January 5, 2016

Subject: **Remediation and Closure Report**
Devon Energy Corporation
Hackberry 16 SWD No. 1
API # 30-015-41783, 2RP-3145 & 2RP-3146

Hackberry 16 SWD #1
Devon Energy Corporation
Eddy County, New Mexico
Figure 1 - Site Plan

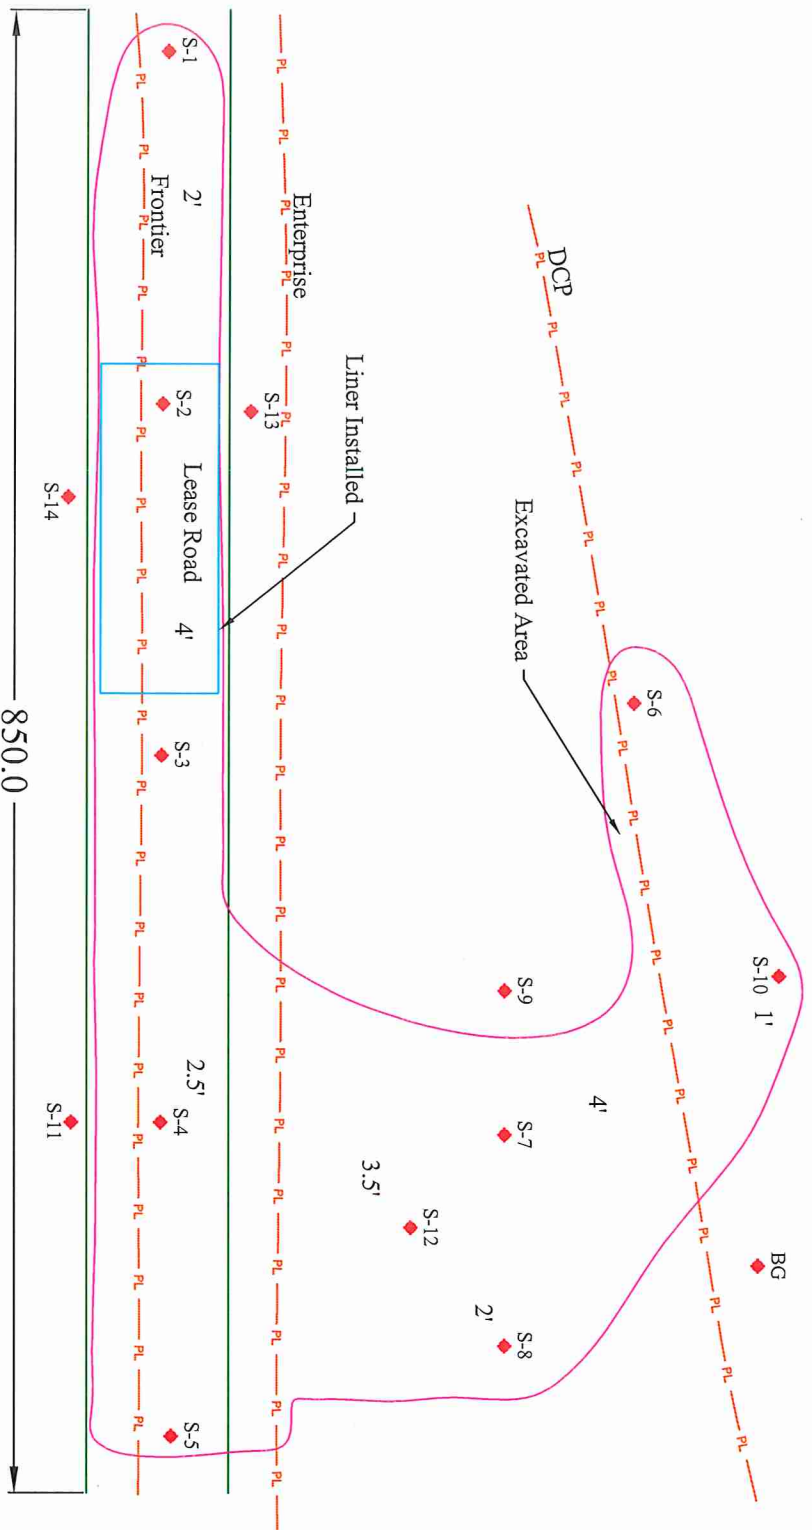
1. Confirmation samples will need to be taken in areas of S-4, S-8 and S-12.
2. BLM agrees with further delineation of S-2, S-3, and S-6.
3. In the area identified as S-6, BLM agrees with the proposed 4' excavation and the NMOCD COA's.
4. Horizontal and vertical confirmation samples will need to be taken in the excavation area.

- Further delineation for chloride will be required in the areas identified as S-2 and S-3. Target delineation goal is 250 mg/kg.
- In the area identified as S-6, OCD agrees with the proposed 4' excavation. Deeper confirmation/delineation sample/samples will be required, with delineation target being 250 mg/kg. OCD does request samples be obtained during excavation of this area from S-6 to the area around the pipeline towards S-7. For this site, if data shows the 4' interval to be in the 1500 mg/kg range, a liner will not be required under the DCP pipeline. Field screens are acceptable for this procedure, including the S-6 delineation.
- Like approval by BLM.

Your proposal for backfill and liner placement at this site is approved. Federal sites require like approval by BLM.

Talon completed excavation activities on October 14, 2015 with confirmation sampling being obtained at that time. Attached please find the complete laboratory report along with a site map. After reviewing the lab data and the stipulations, we request permission to backfill the excavation and to install a liner **ONLY** at sample location S-2 measuring 8' x 70'.
